PUR-1751
ADDENDUM NO. 1
INVITATION TO BID

HAGERSTOWN REGIONAL AIRPORT
EXPAND/REHABILITATE TERMINAL BUILDING EAST

DATE: Thursday, June 12, 2025

FAA ATP No.: 3-24-0019-XX-2025 Bid No.: PUR-1751 MAA Grant No.: MAA-GR-XX-XXX SUBMISSION:	BID SET
SHEET No.:	C1.1
	11 OF 102

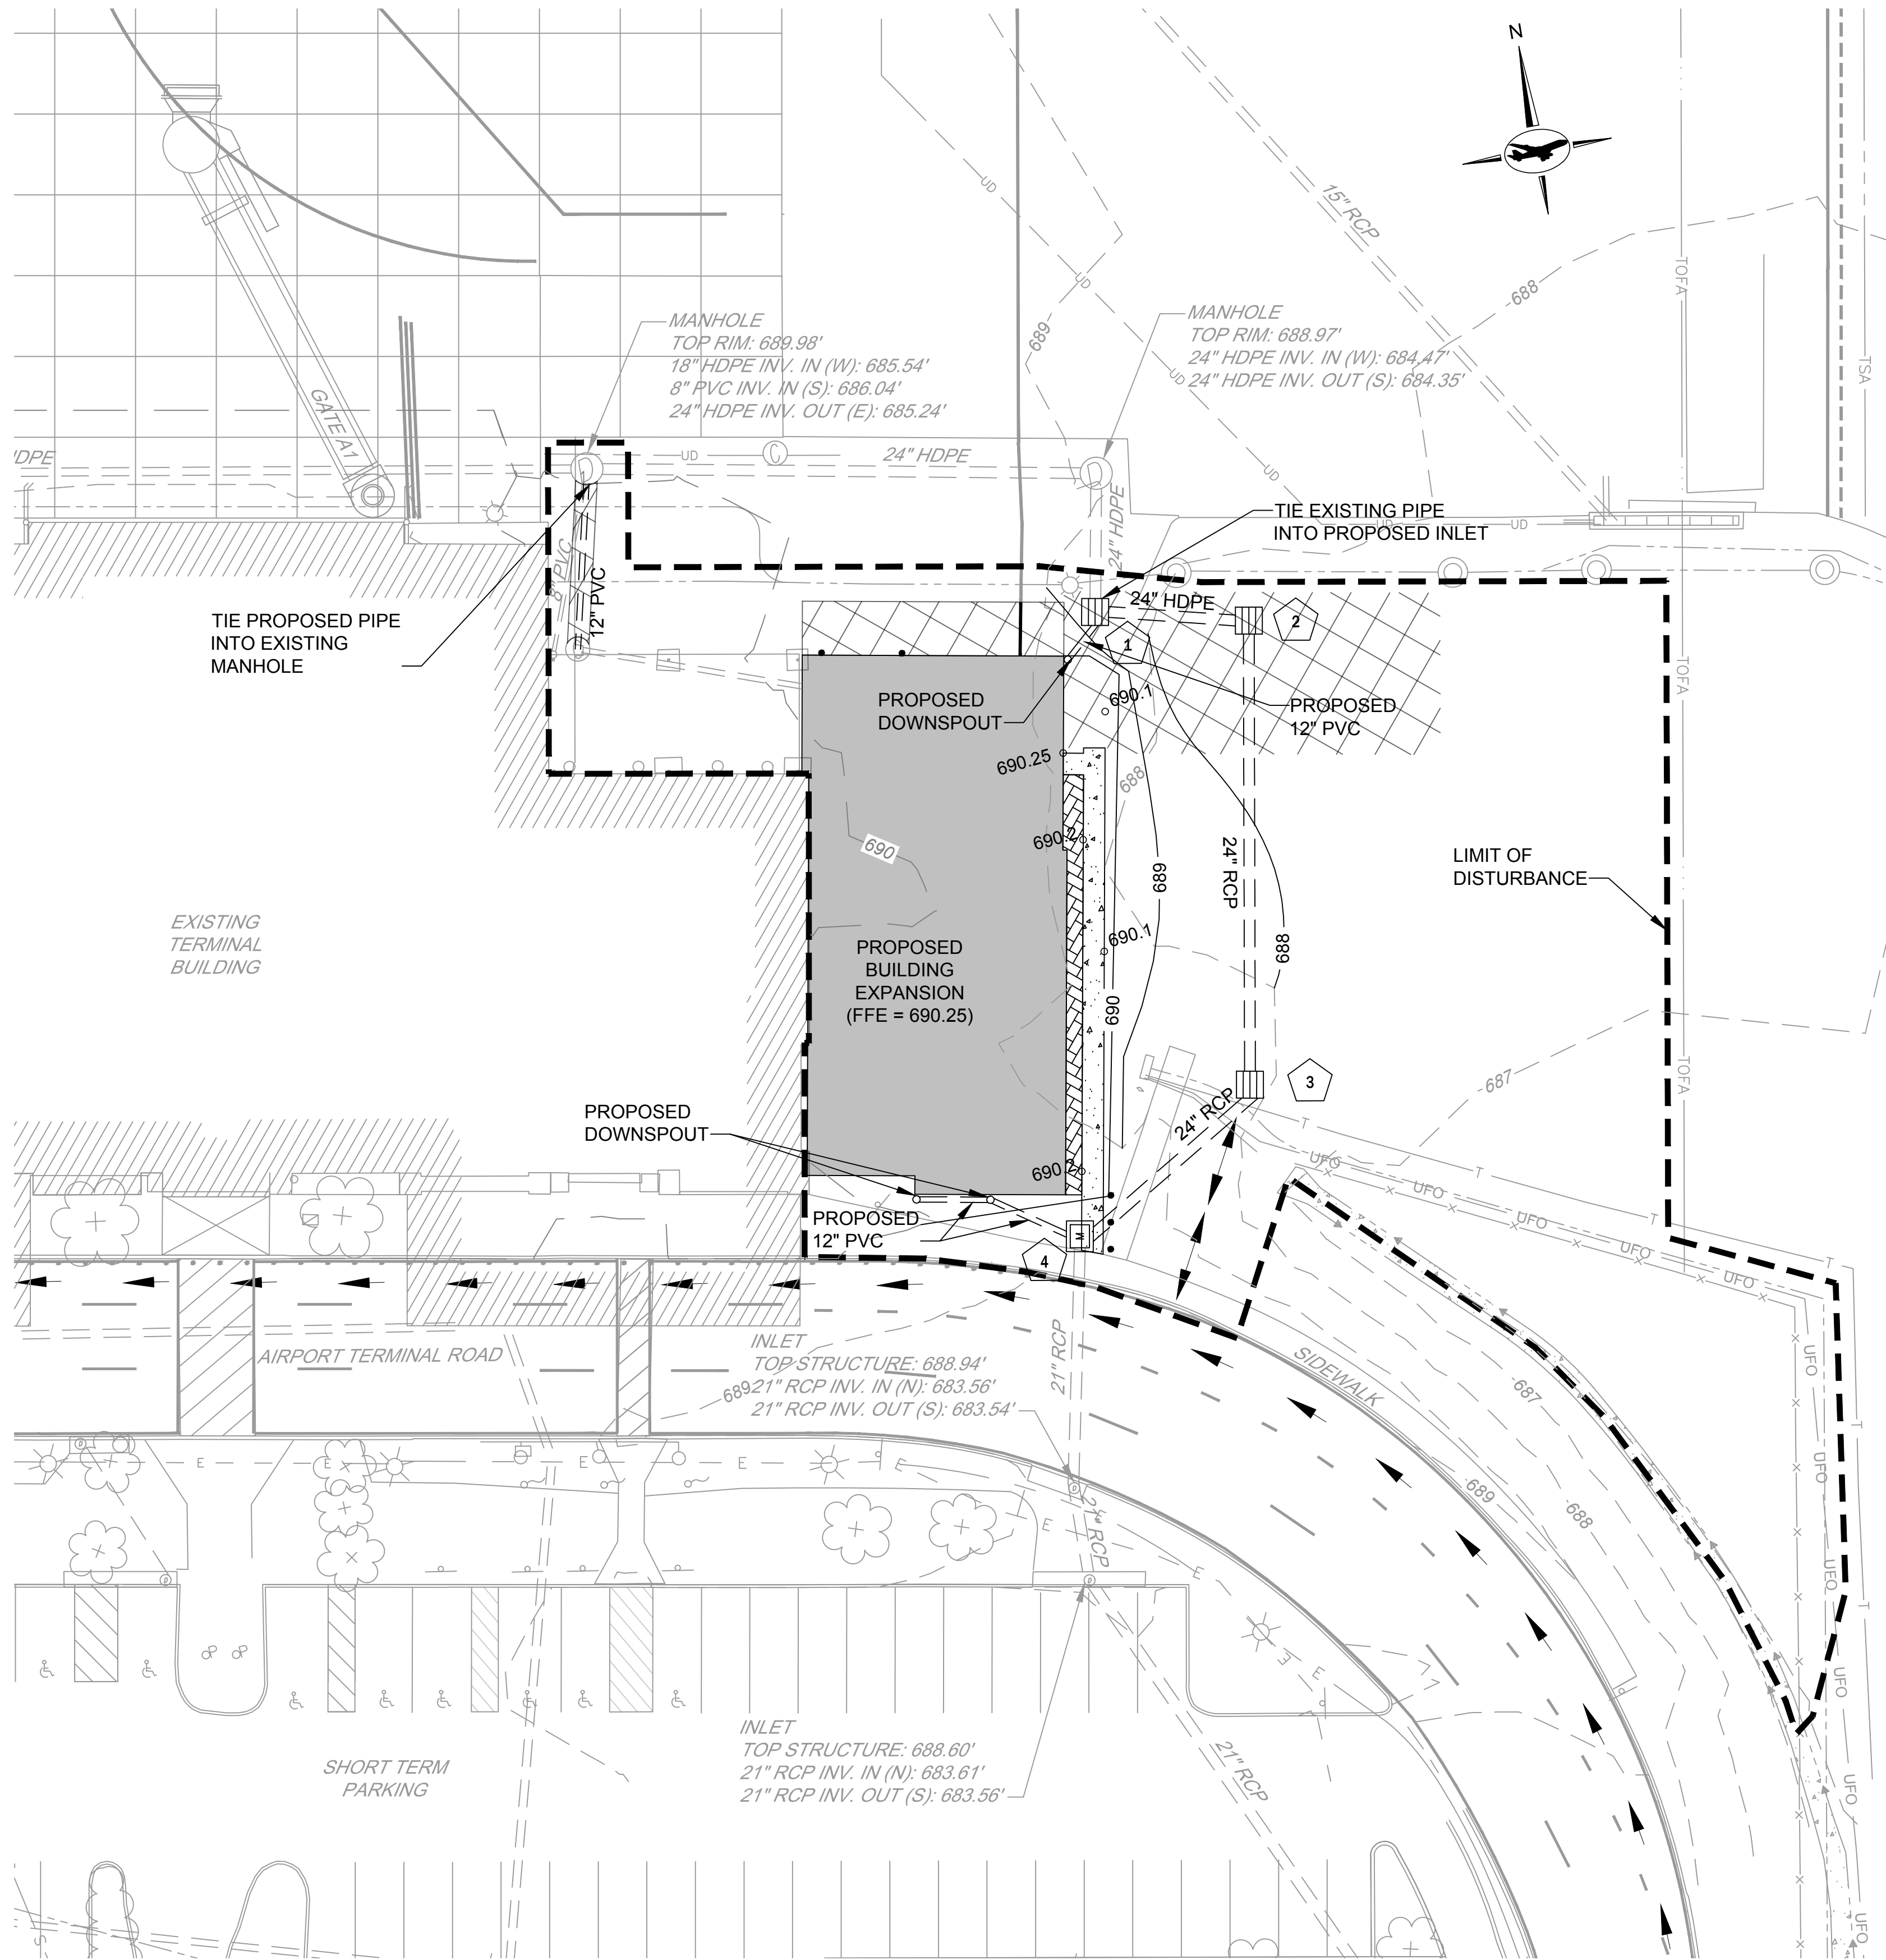
ITEM NO. 17: Sheet No. C1.1 Site Development Plan:

REVISE: Legend to include temporary construction fence.

REVISE: Place callouts for proposed security fence to identify location of tie-in.

FAA ATP No.: 3-24-0019-XX-2025
Bid No.: PUR-1751
MAA Grant No.: MAA-GR-XX-XXX
SUBMISSION: BID SET
SHEET No.: **C1.2**
12 OF 102

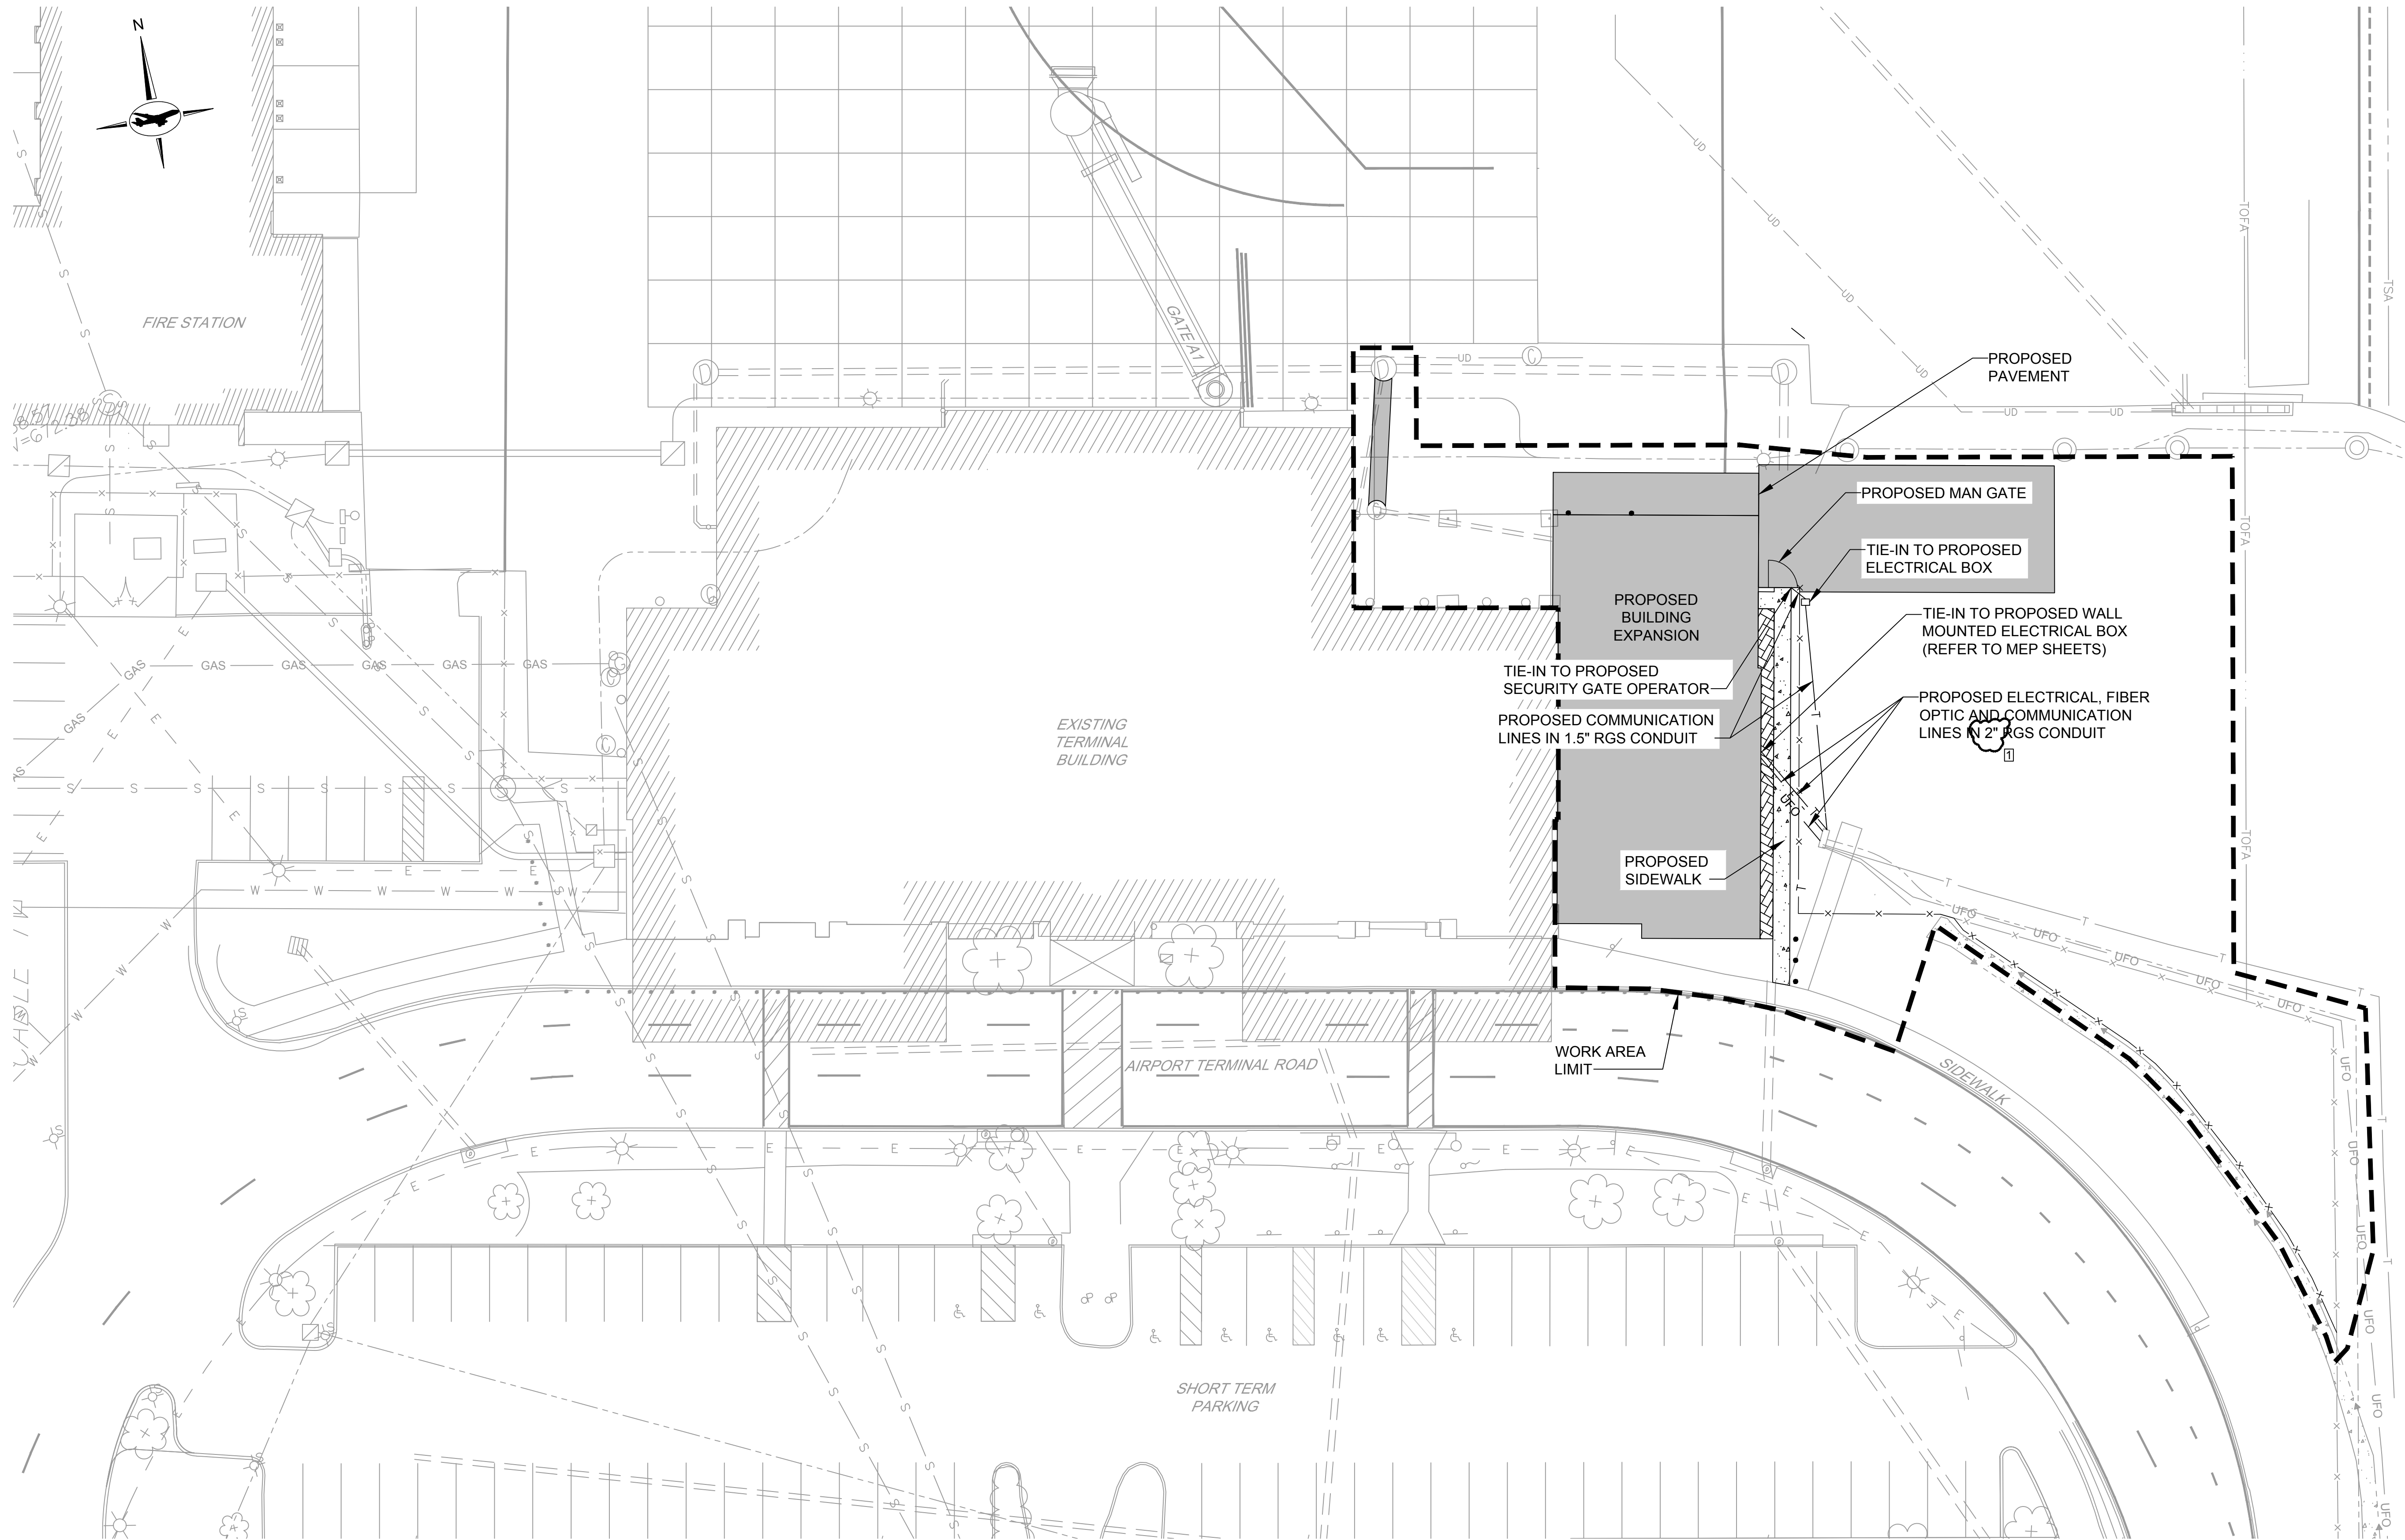
ITEM NO. 18: Sheet No. C1.2 Grading and Drainage Plan:

REVISE: Proposed drainage chart:

- Match top elevation of Structure 4 (Manhole) to proposed ground surface elevation.
- Proposed drainage chart presentation style.

FAA ATP No.: 3-24-0019-XX-2025
Bid No.: PUR-1751
MAA Grant No.: MAA-GR-XX-XXX
SUBMISSION: BID SET
SHEET No.: **C1.3**
13 OF 102

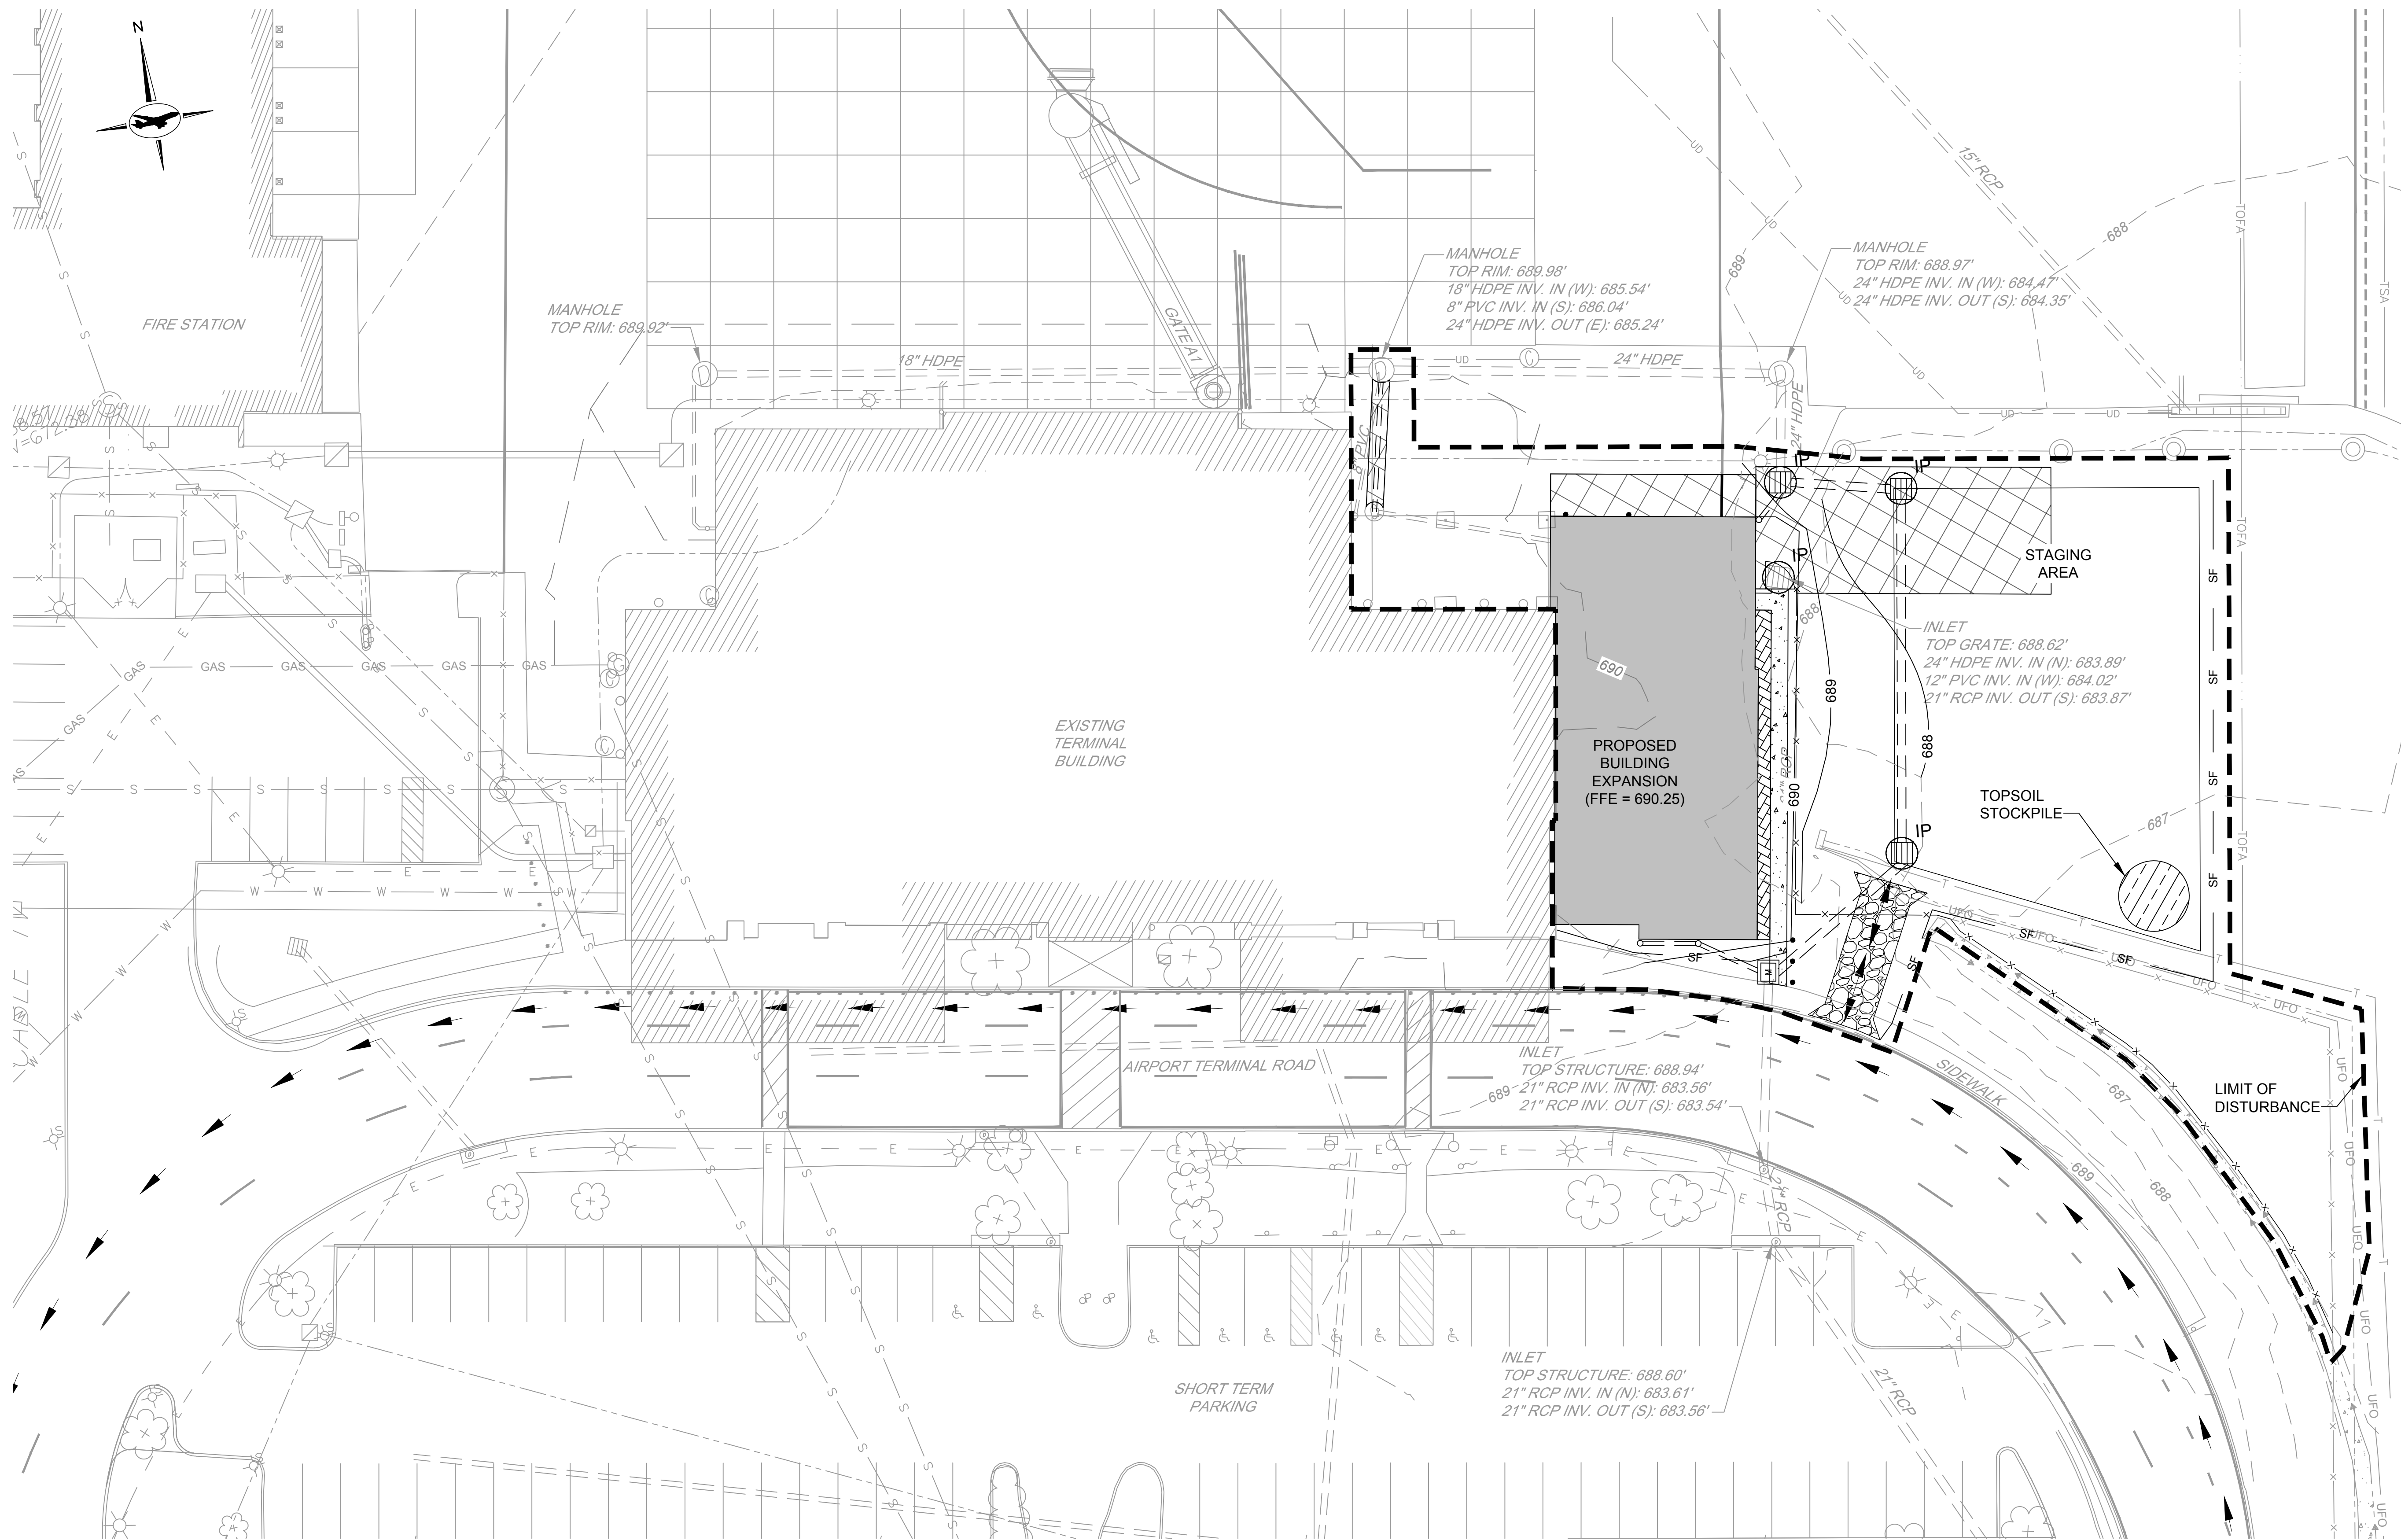
ITEM NO. 19: Sheet No. C1.3 Utility Plan:

REVISE: Callout for Proposed Electrical Fiber Optic to read:

PROPOSED ELECTRICAL FIBER OPTIC AND COMMUNICATION
LINES IN 2" RGS CONDUIT
